REVIEW OF RISK BASED EVALUATION OF
INTEGRATED SAFETY ASSESSMENT (ISAP) ISSUES
FOR MILLSTONE UNIT 1 - PHASE 2

August 15, 1985

U.S. Nuclear Regulatory Commission
Washington, D.C. 20555

Contract No. NRC-03-82-096

Figure 5.1. Logic Trees to Aid in Selection of Expected Behavior Type.

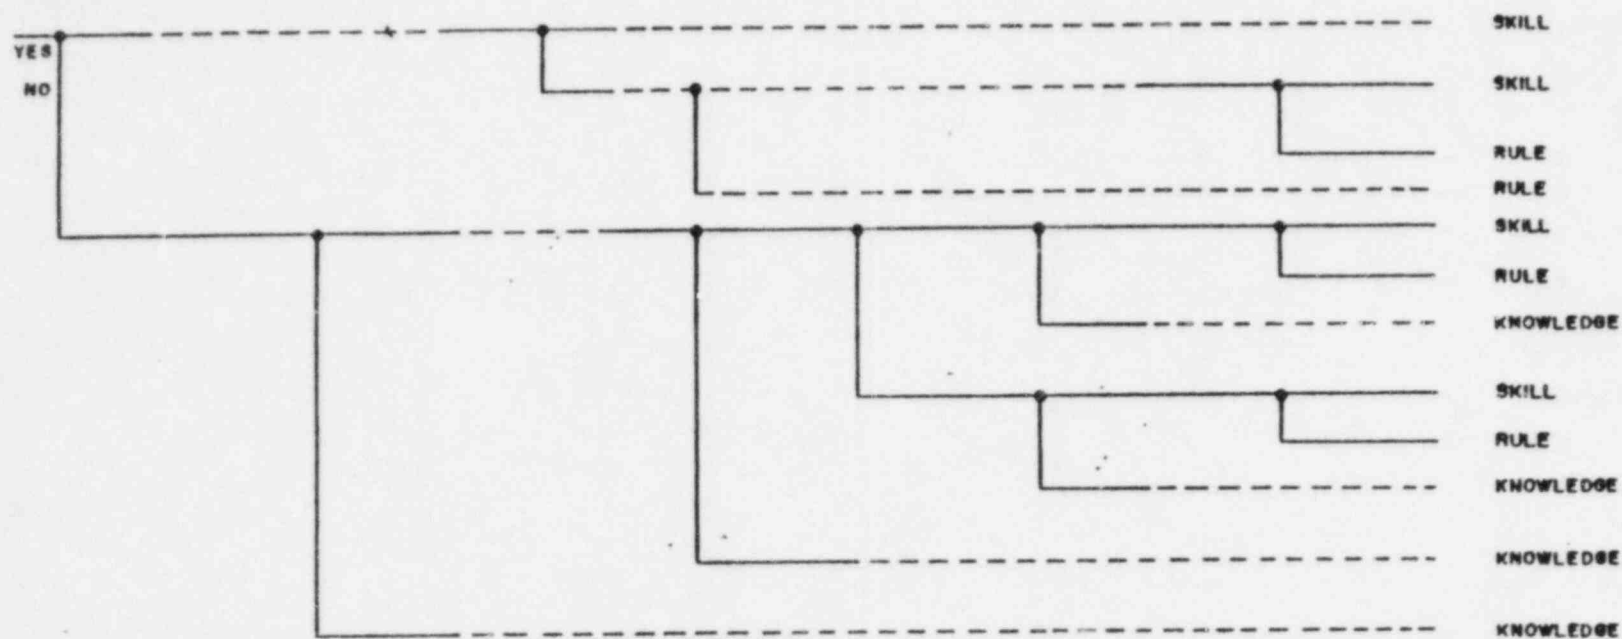
Figure 5.1 is a reproduction of Figure 4.2-3 of the Millstone Unit 1 PSS. This figure shows the logic that was used by each analyst in classification of different human action into one of the above categories. This guideline was used so that the classification done by different analysts is performed in a consistent manner. It should be noted, however, that a certain amount of "analyst creativity" is required in using this logic tree. For example, a nonroutine operation which is covered by a well written, understandable procedure might still be classified as knowledge-based if the amount of time available is short. In this case, the operator

may not have time to access the procedure, which would make the operation equivalent to one which lacked a procedure.

Figure 6.1. Comparison Between Dominant ISAP and IREP Contributors to the Core Melt Frequency.

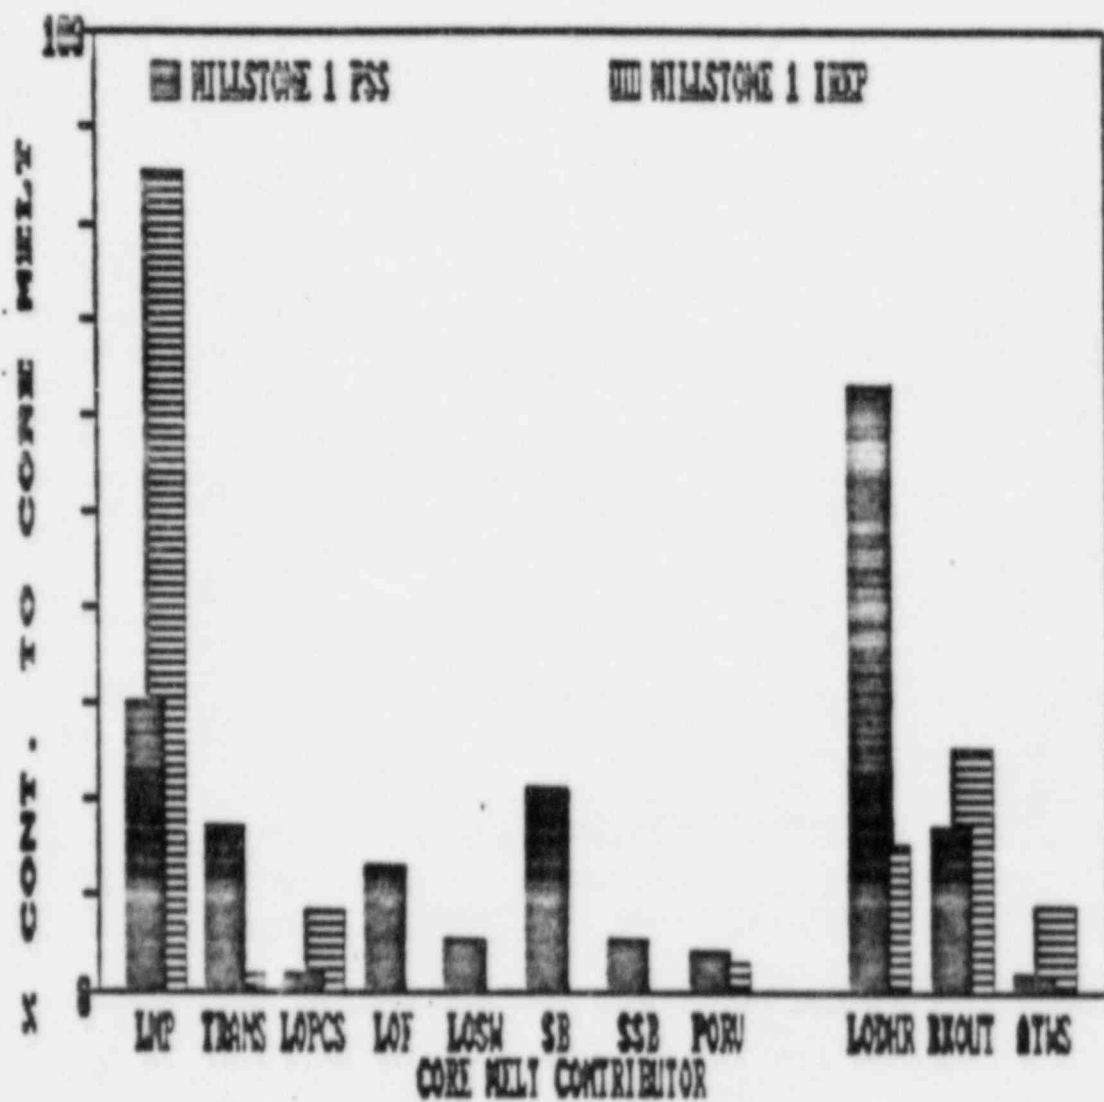
The only mitigative factor that limited the amount of decrease in the ISAP core melt contribution was an increase in the failure probability of the alternate SDC system due to changes in its success criteria.

In addition to the above classes of initiators, three groups of events are also compared in Figure 6.1. The first one is the group of events leading to core melt that include Loss of Decay Heat Removal (LODHR) function. In this case, the ISAP dominant sequence frequencies have increased substantially due to the increased failure probability of the alternate SDC system as a result of the change in its success criteria.

The last group of events shown in Figure 6.1 is the Anticipated Transients Without Scram (ATWS) sequences. The overall ISAP core melt contribution in this case has decreased due to credit allowed for operator action to initiate the standby liquid control system (43 gpm) and take other actions to mitigate the event. This decrease was limited by a significant increase in the RPS failure probability, based on a simple statistical analysis. This event was assumed to lead to core melt in the IREP study. This assumption is one of the topics that will be discussed in more detail in the next section.

The first area is the reliability of the alternate SDC system. Referring to Figure 6.1, it can be seen that sequences involving loss of the decay heat removal system contribute to about 65% of the total core melt frequency. This contribution is substantially higher in the ISAP study compared with the IREP study. As has been mentioned previously, this increase is primarily due to the higher failure probability associated with the alternate SDC system. The increase in the failure probability of the alternate SDC system is due to the change in its success criteria.

Figure 6.2. Simplified Fault Tree for the Failure of Alternate SDC System

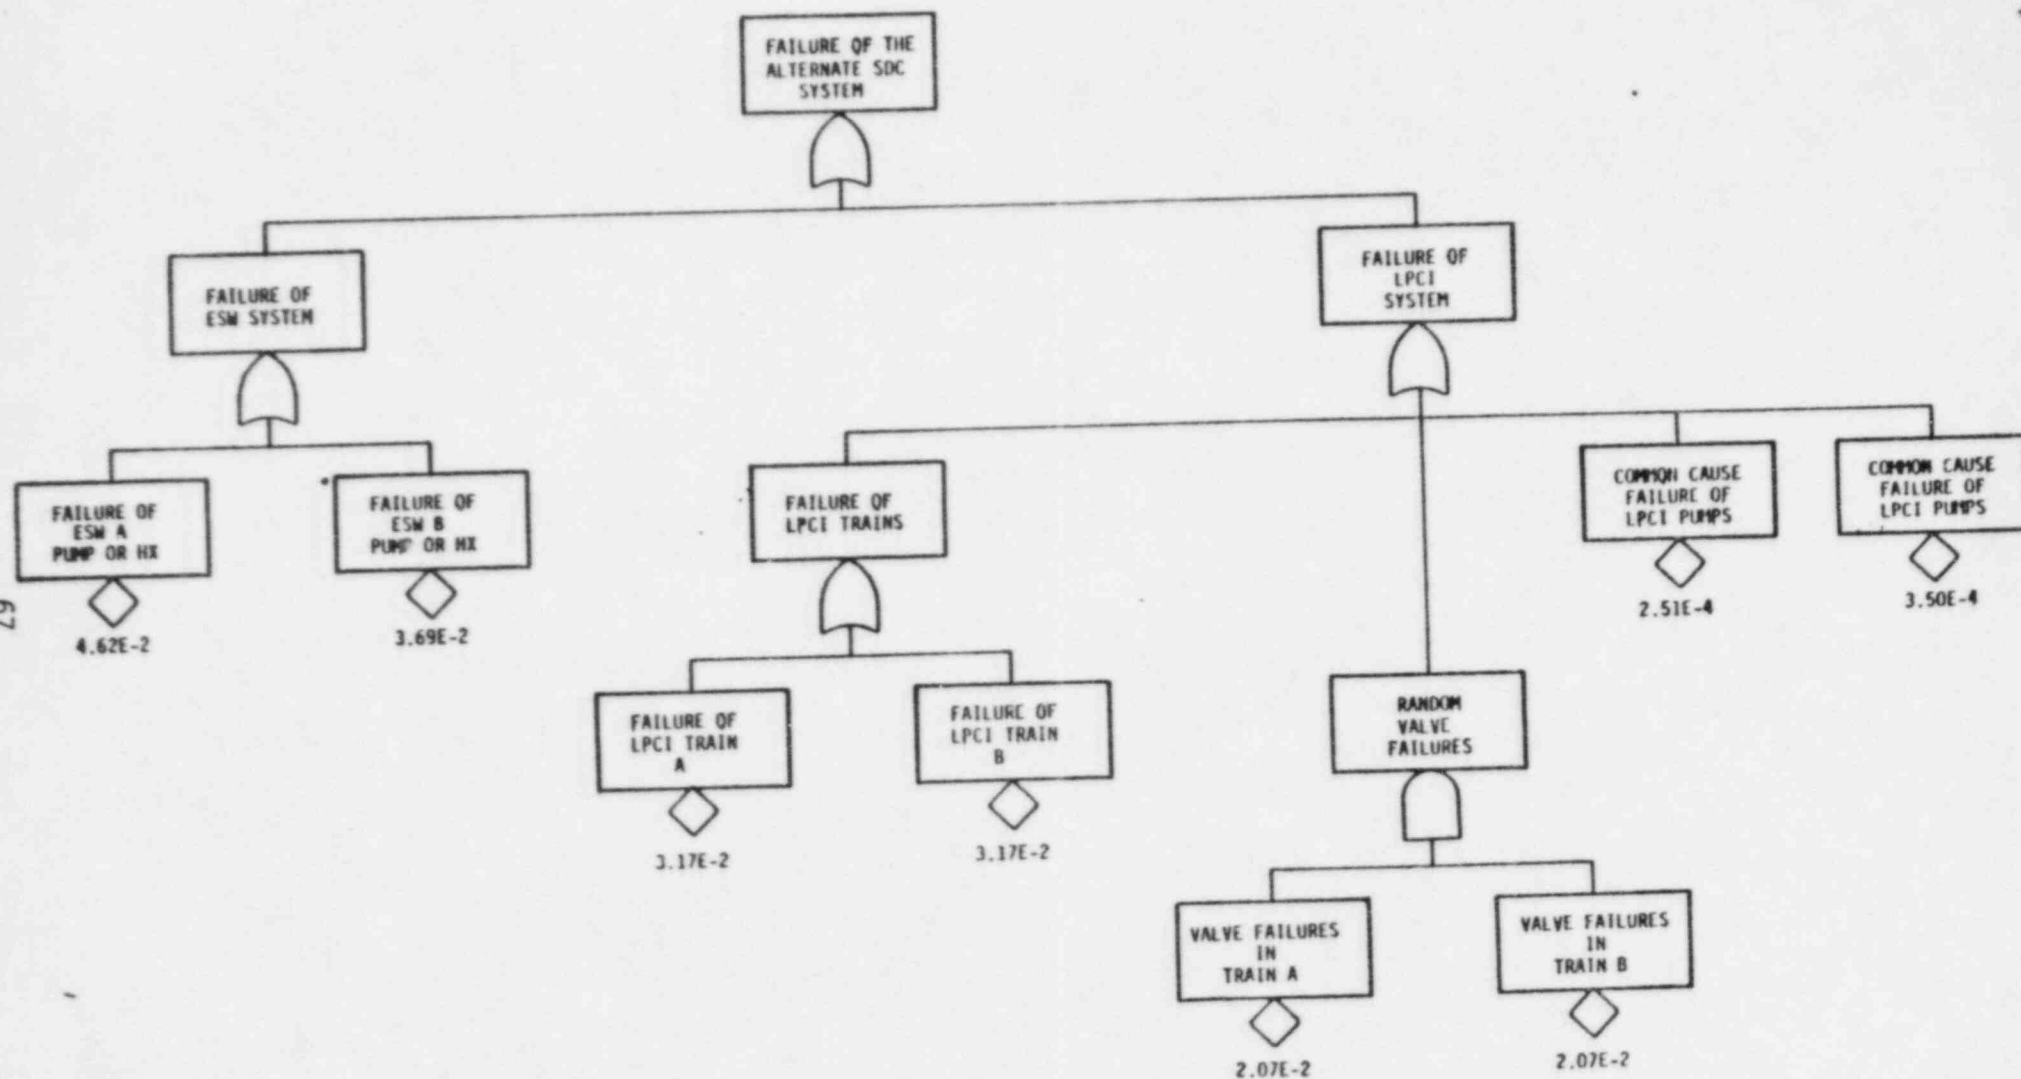
To assess some alternatives in reducing the failure probability of this system, the detailed fault tree for this system, shown in Figure 3.2.24-2 of the Millstone Unit 1 PSS, was simplified and is shown in Figure 6.2. Based on the current configuration, the failure probability of this system with no support system failure is 0.148. Three scenarios for improvement in the reliability of this system were examined. In the first case, it was assumed that the LPCI/containment cooling loops are made redundant. In the second case, it was assumed that the emergency service water loops are made redundant. In the third case, it was assumed that both of the above improvements were incorporated. Table 6.2 shows the results of these evaluations. Incorporation of redundancy in the LPCI alone resulted in the reduction of the failure probability of the alternate SDC by a factor of about 1.7. The effect of making the ESW loop redundant is a reduction in the failure probability of the alternate SDC system by a factor of about 2.2. If both of these changes are incorporated, the failure probability of this system can
